Docket Item # 9-B
DEVELOPMENT SPECIAL USE PERMIT #2002-0001
PRESTON CONDOMINIUM AND TOWNHOMES

Planning Commission Meeting
April 2, 2002

- ISSUE:** Consideration of a request for a development special use permit, with site plan and subdivision, for construction of a multi-family condominium and townhouse project.
- APPLICANT:** A & A Limited Partnership
by Duncan W. Blair, attorney
- LOCATION:** 111 East Reed Avenue
- ZONE:** RB/Residential and CSL/Commercial Service Low
(CRMU-M rezoning pending)

ORIGINAL
CONCEPT
PROPOSAL
ISSUE: RELOCATION
OF CITY PARK FROM
RT. 1 TO E. REED

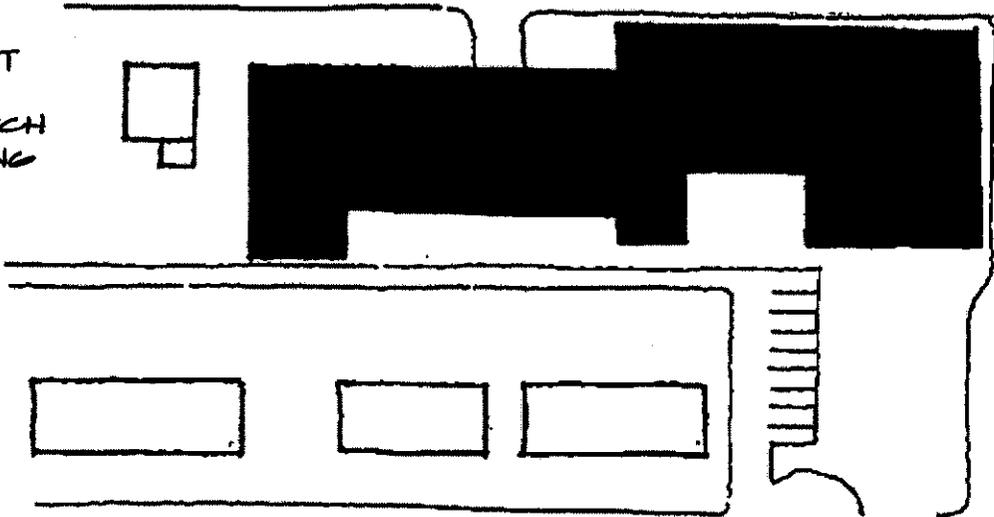
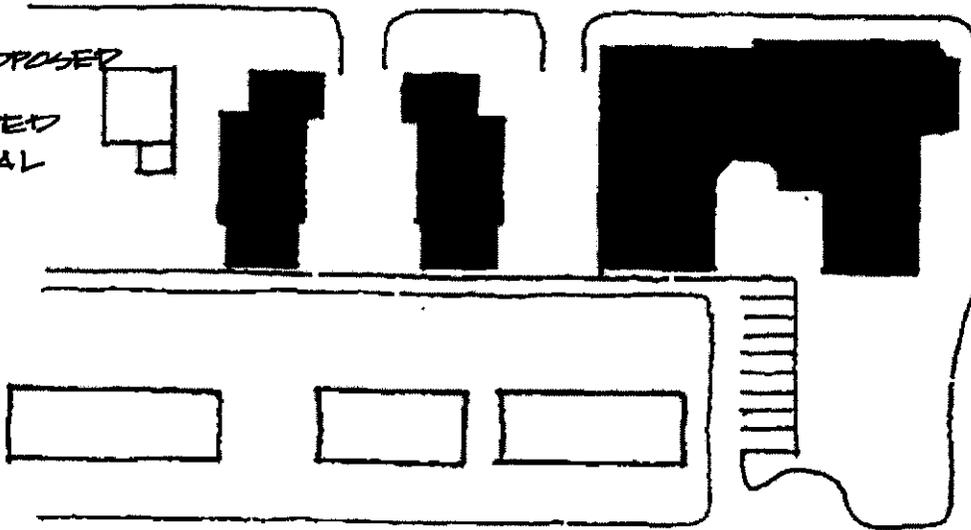
The applicant has worked extensively with staff and the neighborhood to develop a plan that is compatible with the surrounding community. During this process, the plan has changed many times. Initially, the concept for redevelopment incorporated the City park parcel on Route 1 just south of the development parcel, placing a large condominium building entirely along the frontage of Jefferson Davis Highway, and relocating the public park to Reed Avenue (See Illustration "A"). This initial concept had the benefit of keeping the large building on Route 1, where the mass is appropriate, and also placed the park on Reed Avenue, a quieter street potentially conducive to open space. However, the community expressed security concerns about relocating the park to a less visible location on Reed Avenue and also expressed an interest in maintaining the sense of openness along Route 1 at the location of the existing park.

In response to these issues, the applicant then brought forward a plan which left the city park on Route 1 and placed the Condominium building along Reed Avenue, with the size of the building stepping down slightly along Reed Avenue. However, this approach shifted a significant portion of the mass of the condominium building from Route 1, where it was appropriate, to Reed Avenue, where it was out of scale with the existing low scale homes. Working with staff to address this issue, the applicant then revised the plan to significantly reduce the size of the condominium building and to instead build townhomes on the rear portion of the site, creating a transition in scale as one moves west along Reed from Route 1 into the neighborhood. It is this site concept that is now before the Commission and City Council.

COMPARISON BETWEEN SECOND CONCEPT PROPOSAL AND
 CURRENT PLAN

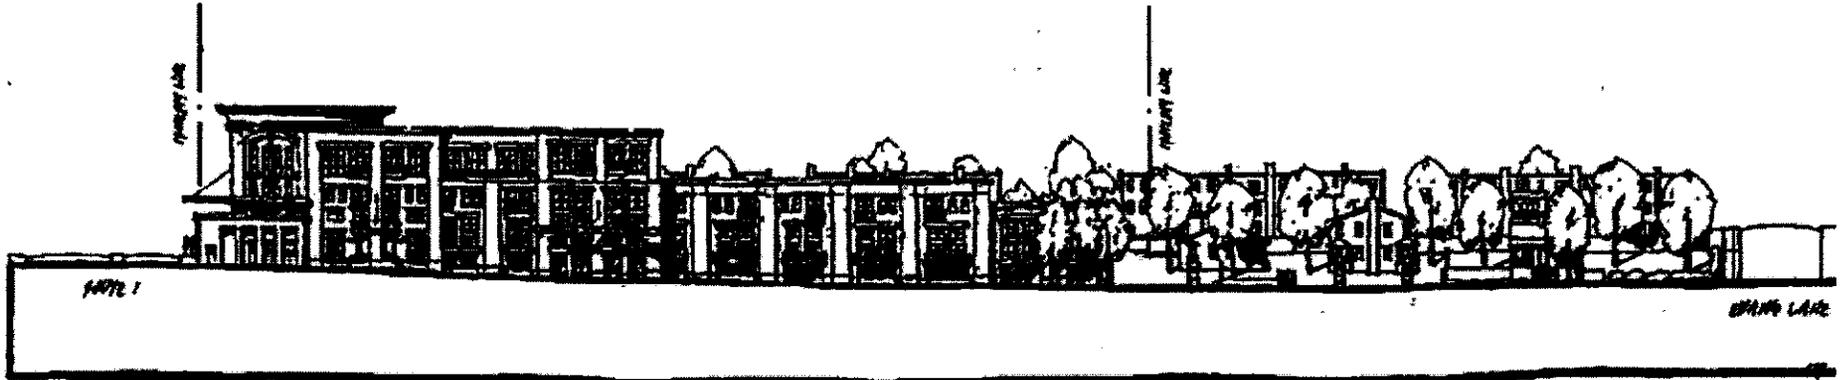
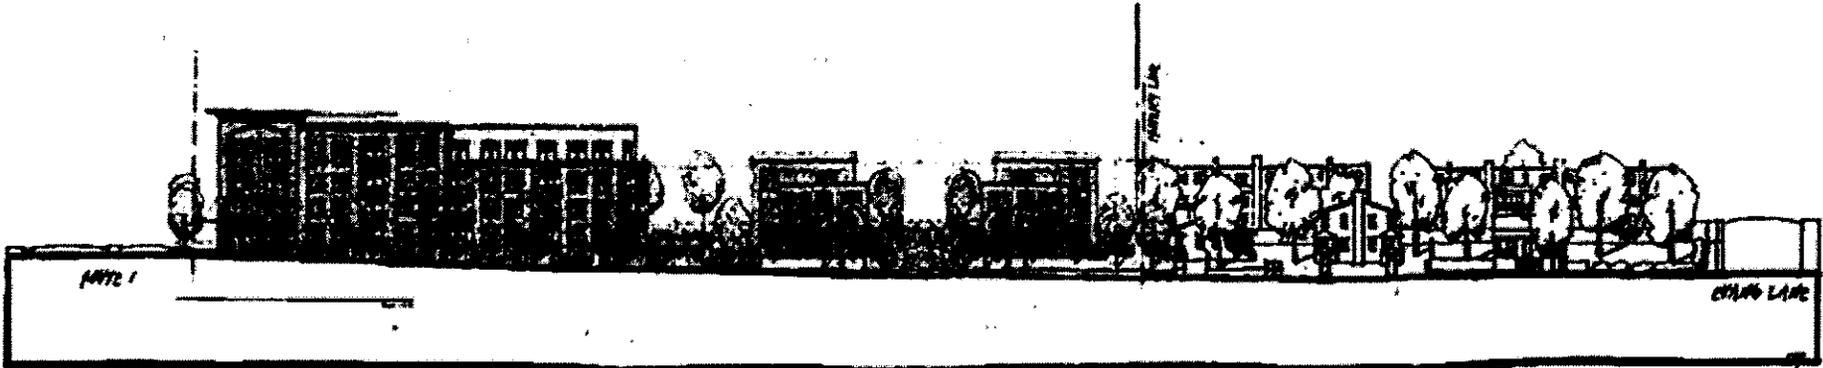
SECOND CONCEPT PROPOSAL FOR ALL
 CONDOMINIUM PROJECT
 ISSUE: TOO MUCH MASSING ALONG REED

CURRENT PROPOSED PLAN FOR CONDO BLDG.
 & TOWN HOUSES - LESS MASSING AND IMPROVED
 TRANSITION BETWEEN CONDO BLDG & EXISTING
 HOUSING ALONG REED

In response to staff concerns about the massing of the condominium building, refinements were made to the building to reduce the overall height of the building, stepping the height of the building back from Reed Avenue and from the homes of Lynhaven residents, and also to break the building visually into smaller elements through additional articulation of the building facade. Improvements were also made to the building to improve its relationship to the street along Reed Avenue, where a portion of the garage is above ground. The garage treated was improved to blend it into the remainder of the building, and individual entrances and stoops were provided for units within the condominium facing Reed Avenue.

5. **CONDITION AMENDED BY PLANNING COMMISSION:** Lower the total height of the condominium building by at least 4 feet. **The height reduction may be achieved by removing at least 3 feet from the top floor of the condominium building and 1 foot from the parapet.** ~~, including at least 3 feet out of the top floor and parapet, and~~ **The applicant will** work with staff to refine the proportions of the cornice and window proportions in order to reduce the mass and scale of the condominium building's top floor, to the satisfaction of the Director of P&Z. (P&Z) **(PC)**

- ① ORIGINAL PROPOSED DRIVEWAY (PARKING COURT) GRADE
- ② MODIFIED REDUCED DRIVEWAY COURT GRADE
- STAFF RECOMMENDING DRIVEWAY COURT GRADE: 2%

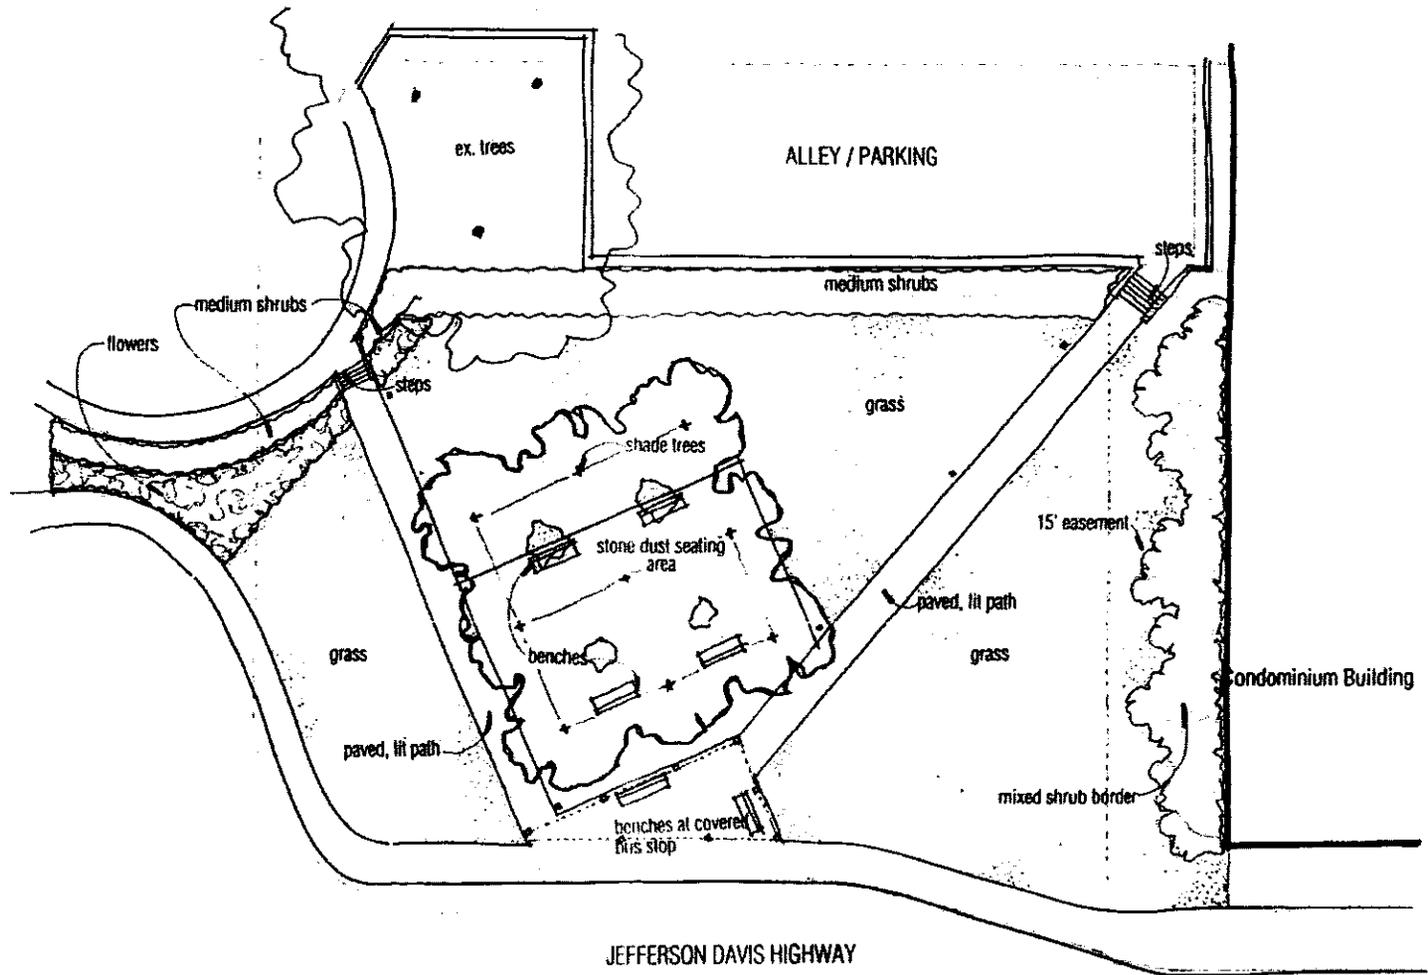
The grade of the townhouse site ascends upward toward the rear of the site, an overall height change of seven to eight feet. Staff believes that the upward slope of the driveway court will be highly visible from the street. To reduce views of the paving and parked vehicles, staff requested the applicant flatten out the grade of the parking court and pull the two end units inward, reducing the view of pavement from the street. The applicant did pull the two end units inward and this change is reflected in the plans. However, the grade was not flattened because, according to the applicant, an existing retaining wall at the rear of the site which is being maintained limits the ability to shift the grades. The applicant's engineer stated that lowering the grade would require removal of the existing retaining wall because the footings probably do not extend deep enough to allow extensive excavation to flatten the grade. However, the applicant has proposed to reduce the grade more than what is currently being shown on the plans. This reduces the percent of grade from approximately 5½% to 2%, which will lessen somewhat the extent of the pavement visible from East Reed Avenue. In addition, the applicant has reduced the total amount of pavement in the court area by eliminating some tandem spaces and adding additional green areas and landscaping. The applicant has also proposed using higher quality paving materials such as brick or block instead of asphalt.

1. **CONDITION AMENDED BY PLANNING COMMISSION:** To reduce the amount and visibility of the pavement between the two rows of townhomes:
 - a) Grade the site so that the driveway rises 12% from the sidewalk and then flattens (slope grade no greater than ~~2%~~ 4.2%) in front of the townhomes, rather than continuing to rise in grade toward the rear of the site.
